PLANNING COMMISSION AGENDA

MONDAY, JUNE 13, 2016; 5:30 PM WORKSESSION, 7:00 PM REGULAR MEETING,
COUNCIL CHAMBERS, 707 W. ACEQUIA, VISALIA CA

REPORT TO CITY OF VISALIA PLANNING COMMISSION

SITE PLAN NO: SPR16029
PROJECT TITLE: SUNCREST BANK
DESCRIPTION: NEW PARKING LOT AND BUILDING RENOVATION (CDT) (AE) (DRD)
APPLICANT: TETER A+E
PROP OWNER: SUNCREST BANK
LOCATION: 501 W MAIN ST
APN(S): 093-195-005

FIGURE D103.1
DEAD-END FIRE APPARATUS ACCESS ROAD TURNAROUND

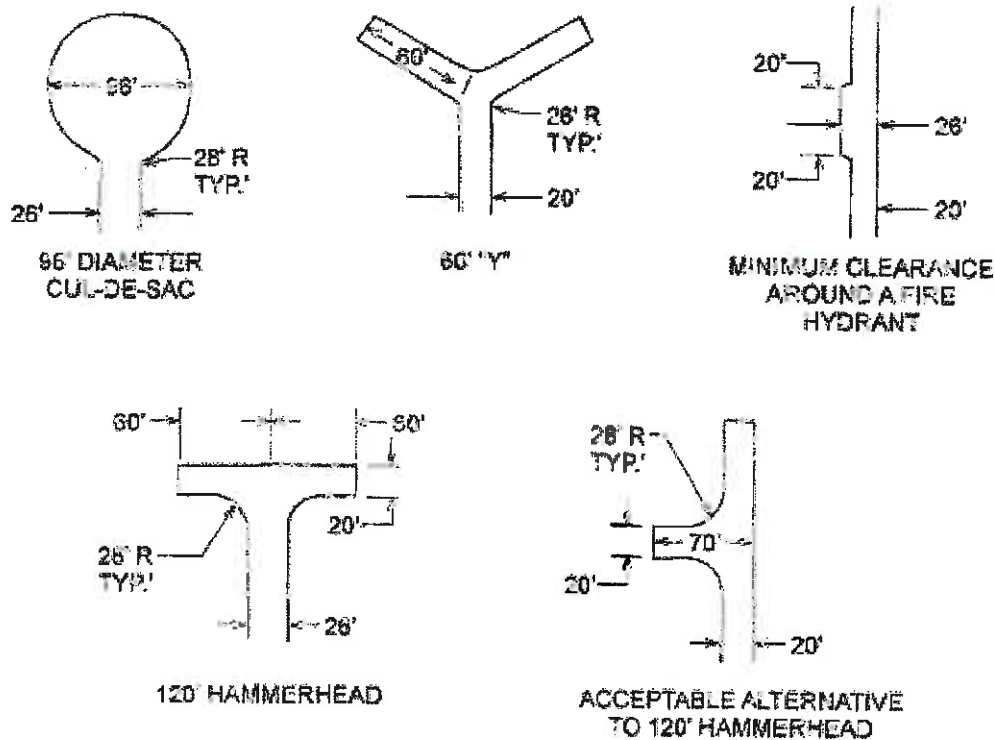
- Fire apparatus access roads in excess of 150 feet and dead end shall be provided with a turnaround. Length 151-500 feet shall be a minimum of 20 feet in width and have a 120 foot Hammerhead, 60-foot "Y" or 96-Foot diameter Cul-de-sac in accordance with Figure D103.1 of the 2013 CFC. Length 501-750 feet shall be 26 feet in width and have a 120 foot Hammerhead, 60-foot "Y" or 96-Foot diameter Cul-de-sac in accordance with Figure D103.1 of the 2013 CFC.

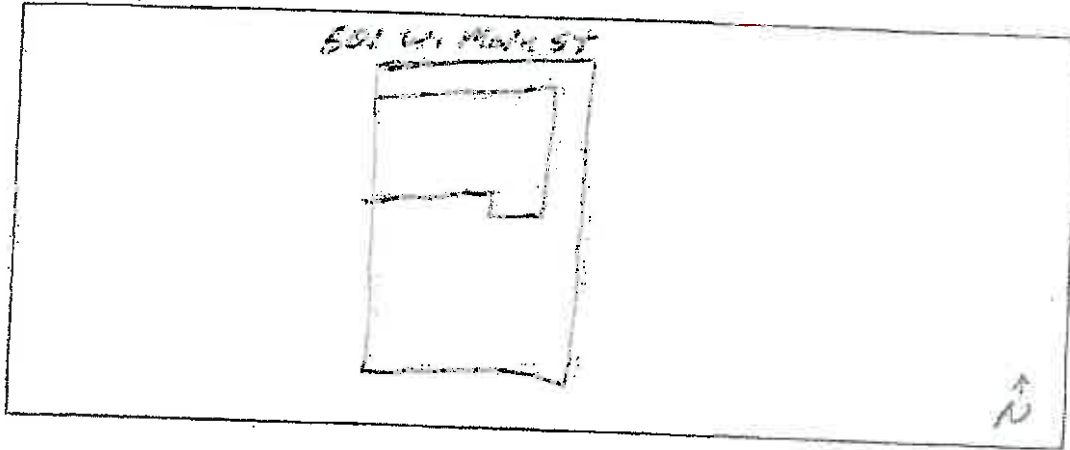
1) WHEN ALTERATIONS OR ADDITIONS ARE MADE TO EXISTING BUILDINGS OR FACILITIES, AN ACCESSIBLE PATH OF TRAVEL TO THE SPECIFIC AREA OF ALTERATION OR ADDITION SHALL BE PROVIDED UNLESS OTHERWISE EXEMPT.

2) PRIMARY ACCESSIBLE PATH OF TRAVEL SHALL INCLUDE
① A PRIMARY ENTRANCE TO THE BUILDING OR FACILITY,
② TOILET FACILITIES SERVING THE AREA, ③ DRINKING FOUNTAINS SERVING THE AREA, PUBLIC TELEPHONES SERVING THE AREA, AND SIGNS.

*FIGURE D103.1
DEAD-END FIRE APPARATUS ACCESS ROAD TURNAROUND*

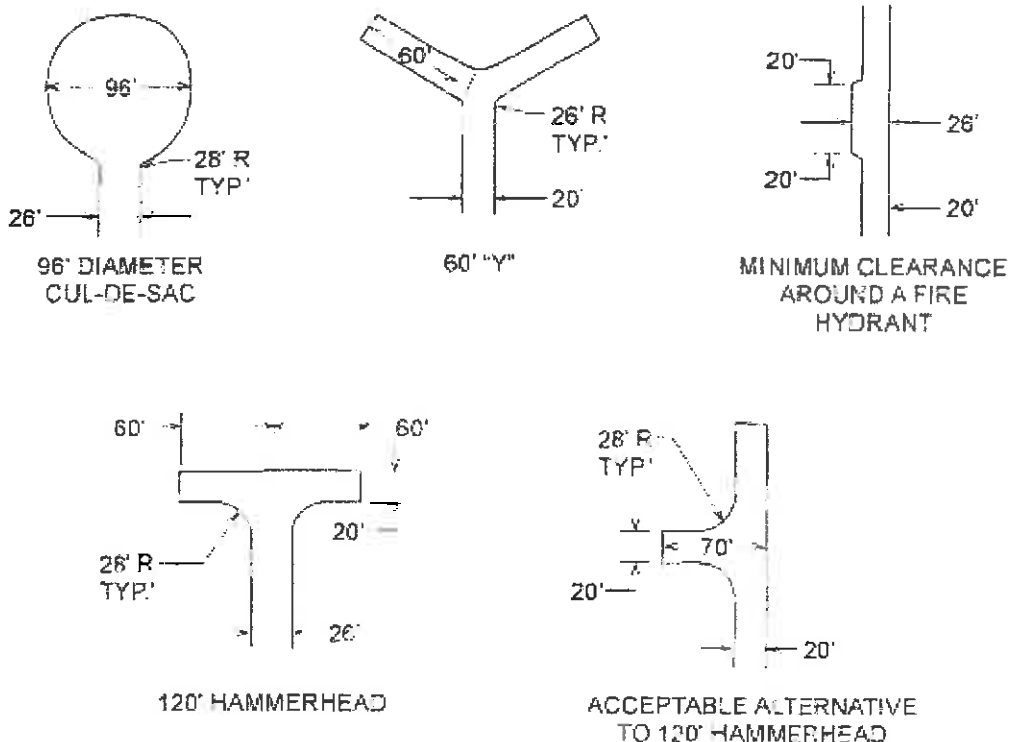
- ☒ Fire apparatus access roads in excess of 150 feet and dead end shall be provided with a turnaround. Length 151-500 feet shall be a minimum of 20 feet in width and have a 120 foot Hammerhead, 60-foot "Y" or 96-Foot diameter Cul-de-sac in accordance with Figure D103.1 of the 2013 CFC. Length 501-750 feet shall be 26 feet in width and have a 120 foot Hammerhead, 60-foot "Y" or 96-Foot diameter Cul-de-sac in accordance with Figure D103.1 of the 2013 CFC.

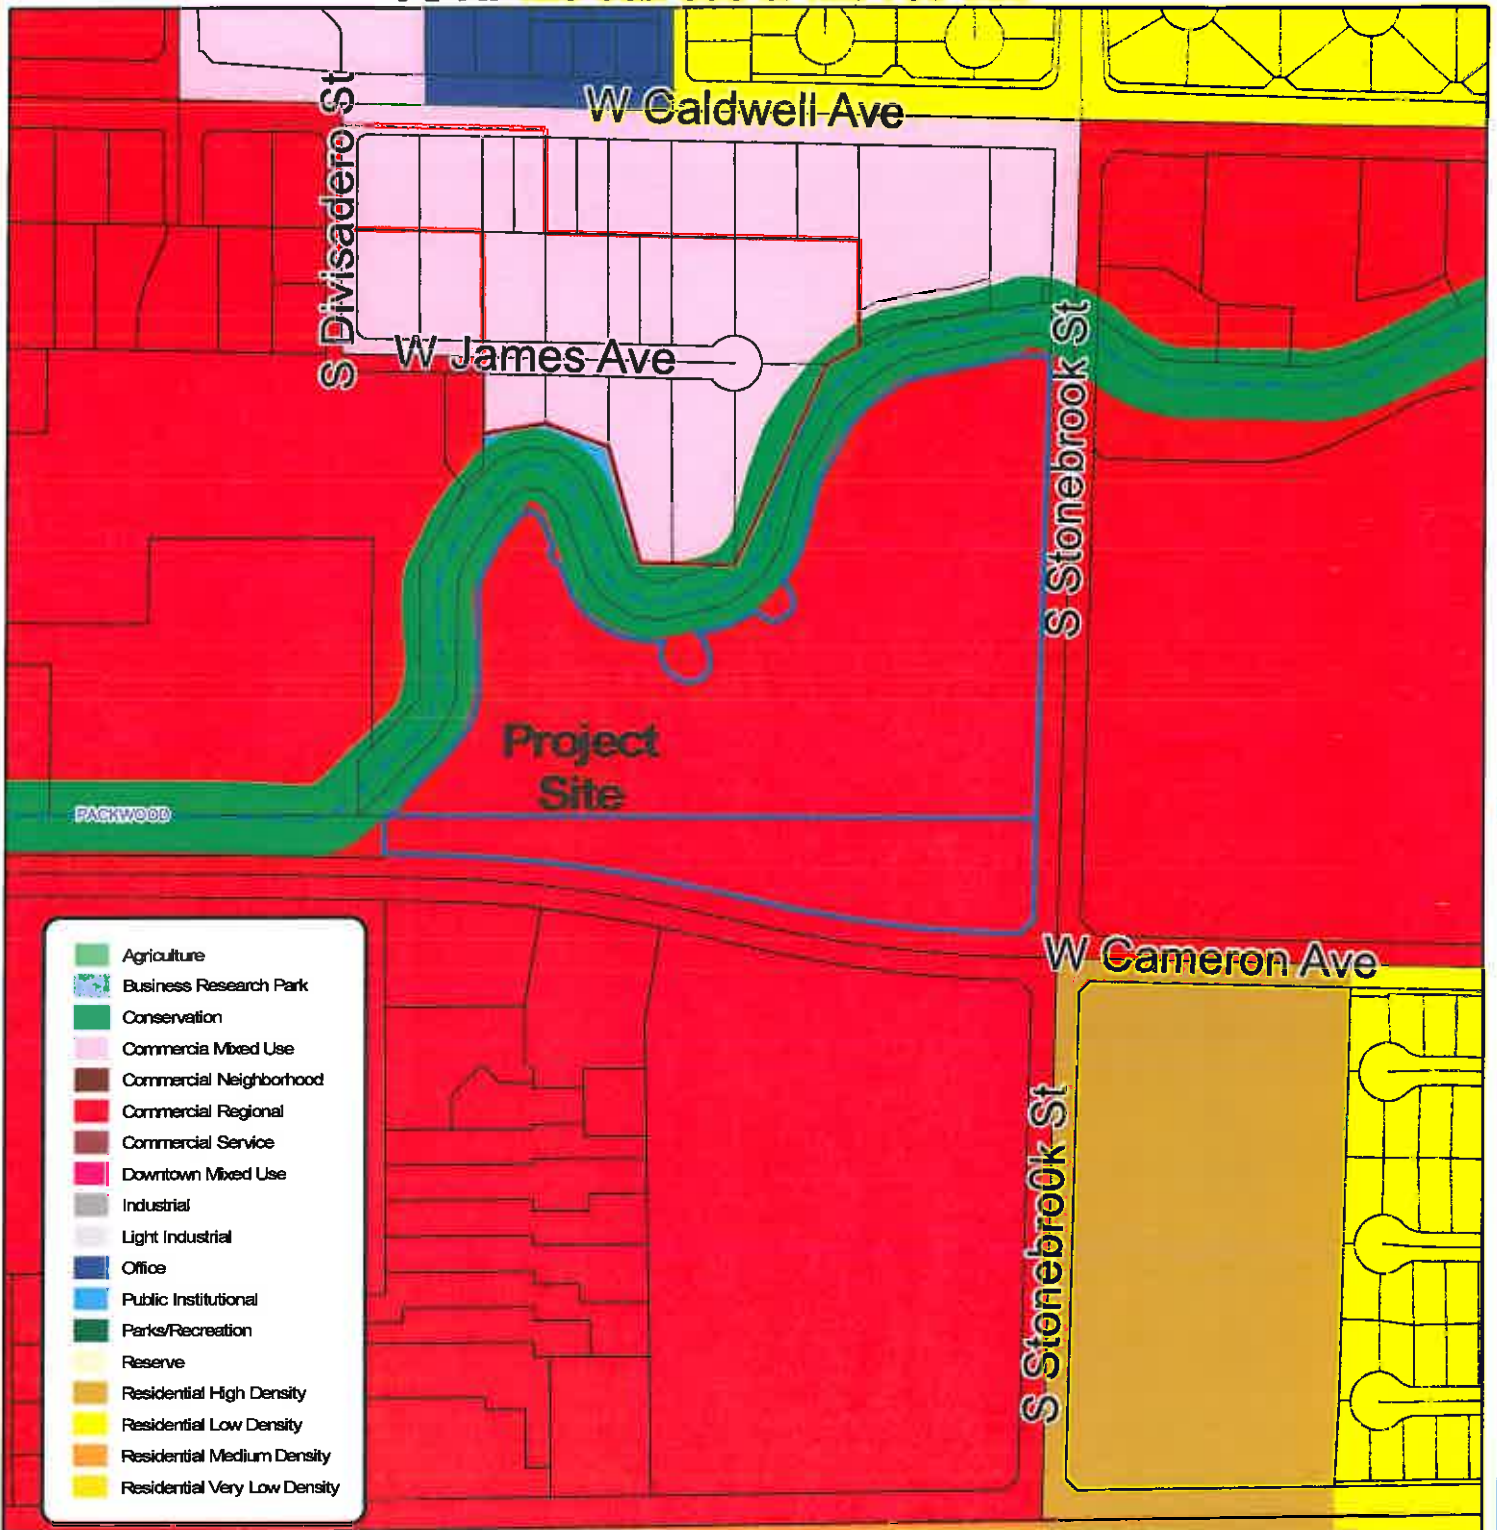
- Driveway shall align with Costco driveway to the south.
